Report: TAB

Function: Test, Adjust, & Balance

Date: 08/06/2025

**08-04-25 CHIPOTLE #5495 GLOUCESTER,
MA**

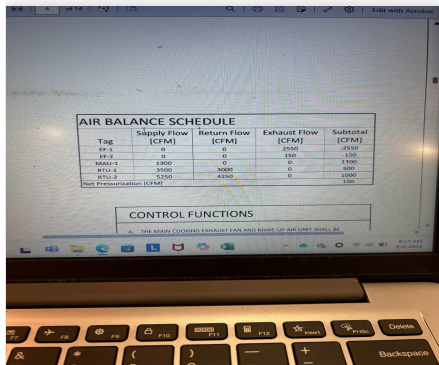
Issue Name : Balance schedule
Description : Balance schedule doesn't not reflect the drawings. RTU 1 adds up to 100 CFM less. Change was made on the report.
Created By : National TAB **Assigned To :** National TAB - Dan Hertenstein
Status : Open
Priority : InfoOnly **Asset Tag :** HVAC EQUIPMENT 1
Originated Date : 08/06/2025 - Jearod Ferrette - National TAB

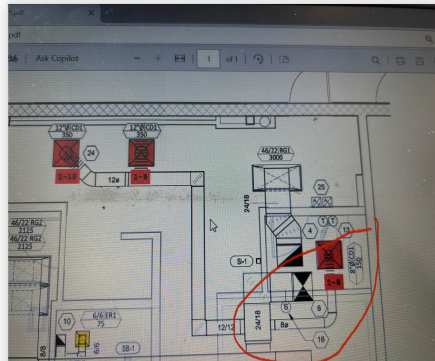
Issue Name : Miss damper in office
Description : Missing damper on manager office. (SGRD 1-8) Currently at 231% of design 150 CFM., which is stealing air from the last 2 diffusers. Unit is at total flow.
Created By : National TAB **Assigned To :** National TAB - Dan Hertenstein
Status : Open
Priority : Medium **Asset Tag :** SGRD8
Originated Date : 08/06/2025 - Jearod Ferrette - National TAB
